27 April 2007

MEMORANDUM

SUBJECT: Idaho National Laboratory Reactor Technology Complex Cold Waste
Pond Wastewater Reuse Permit Application Review -- LA-000161-01
(Industrial Wastewater Facility)

Figure 1. Aquifer and perched wells at the site, including proposed monitoring wells.

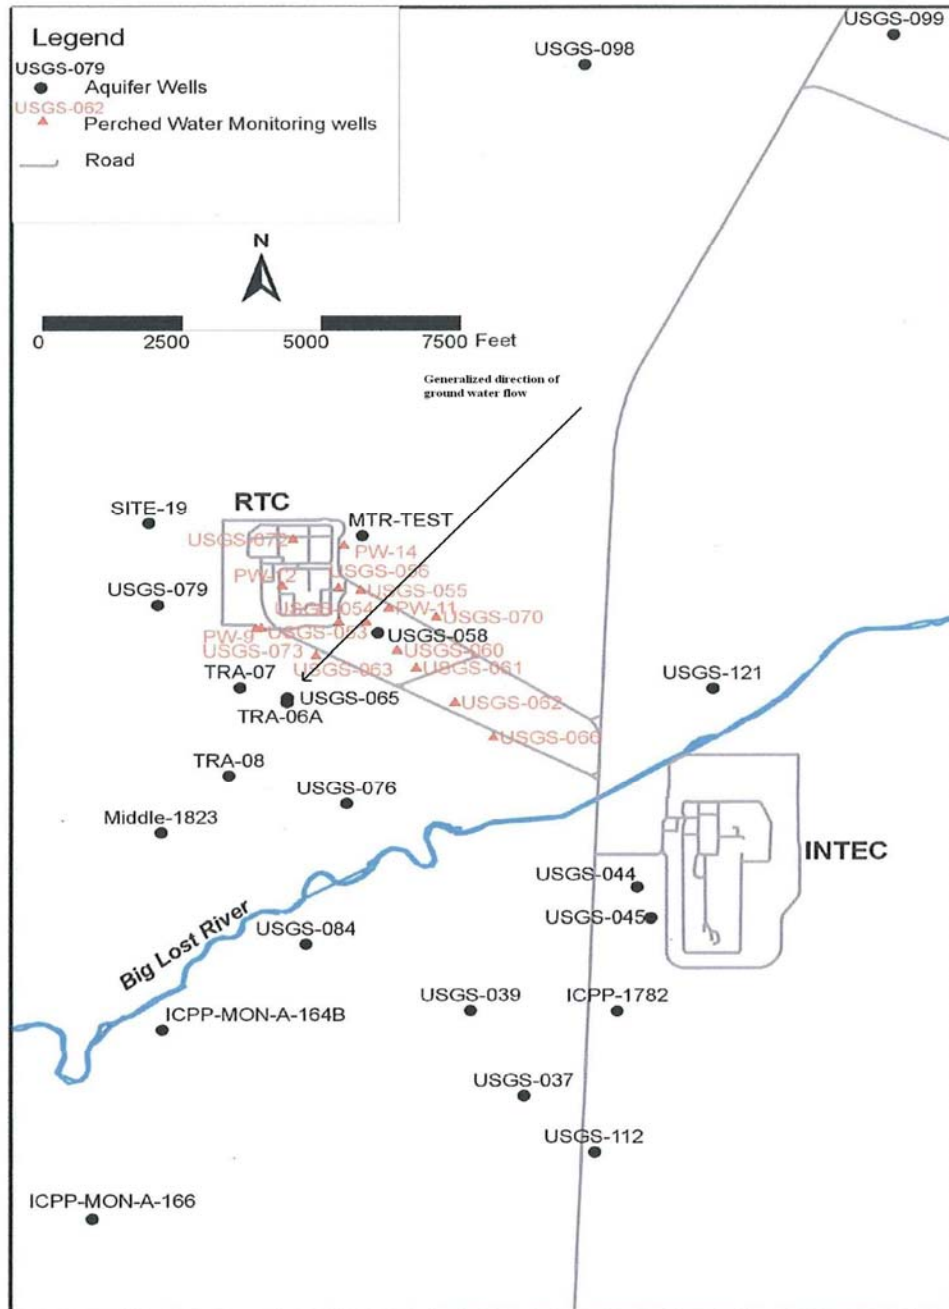
The facility is proposing the use of four (4) wells to determine compliance with the Idaho Ground Water Quality Rule at the CWP (TRA-03, TRA-07, USGS-65, and USGS-76). All four of the proposed wells are completed in the regional Snake River Plain Aquifer (SRPA), located approximately 480 feet below the site, rather than either the shallow or deep perched-water bodies that have formed as a result of infiltration from the various unlined ponds on the site. See Figure 1 for monitoring wells located at the site (Note: As TRA-03 is a production well, it is not included in this figure).

Given that aquifer flow is to the southwest, Well TRA-03 is virtually the only well in the area positioned to provide up/cross-gradient aquifer water quality data as it is located in the upper northeast corner of the facility, up-gradient of not only the CWP but the other former percolation ponds in the immediate area. However, as it is also one of the RTC's production wells rather than a monitoring well, there is some question as to how reflective its water quality is of actual ambient up-gradient concentrations, in part due to the fact that the well pumps from a greater depth than the others. Wells USGS-065, TRA-07, and USGS-076 are proposed to monitor the aquifer down-gradient of the CWP. USGS-076 most likely occupies a more cross/down-gradient position, and its water quality more closely resembles that of TRA-03 than either USGS-065 or TRA-07. See Table 2 for averages of the laboratory results for these wells from 2000-2005 and comparison with their corresponding Ground Water Quality Standard (IDAPA 58.01.11.200).

discharge to the CWP, contaminant levels in the perched zone monitoring wells tend to fluctuate (DOE, 2005). While the vast majority of these contaminants can be attributed to historic sources that have since been remediated, their continued presence makes monitoring for compliance within the perched water zones impractical. Staff recommends that the proposed up-gradient well TRA-03 and down-gradient wells USGS-65, TRA-07, and USGS-076, as well as TRA-08 and Middle-1823, be monitored for compliance twice per year (April and October) as a condition of the draft permit.

Figure 2. Deep perched water wells impacted by CWP

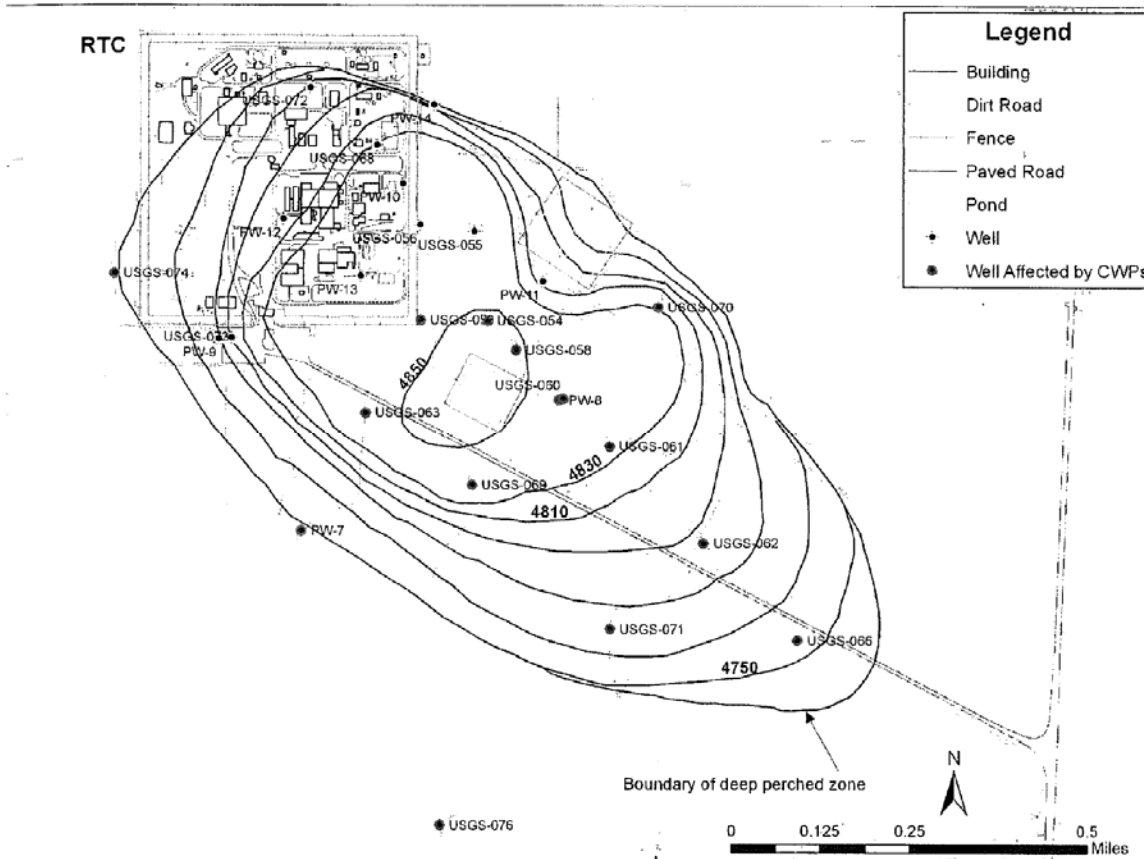
The shallow perched zone has eleven monitoring wells; however, as water levels in both zones tend to fluctuate in relation to hydraulic loading rates at the CWP, only two have remained consistently wet (CWP-1 and CWP-9). The deep zone has a network of 17 wells which are monitored for contaminants of concern, such as chromium and selected radionuclides under the CERCLA Record of Decision (ROD) for Operational Unit (OU) 2-13. See Figure 2 for perched wells on the site.

It is clear that the years of high sulfate loadings from the CWP have contributed to the elevated levels of the constituent in both the shallow and deep perched waters. The chromium contamination also appears to be more marked in these sets of monitoring wells because while only one well (USGS-066) shows levels above the ground water quality standard; several of the wells show levels of chromium above the pond's average and maximum effluent concentrations. Due to a number of factors, including the variable
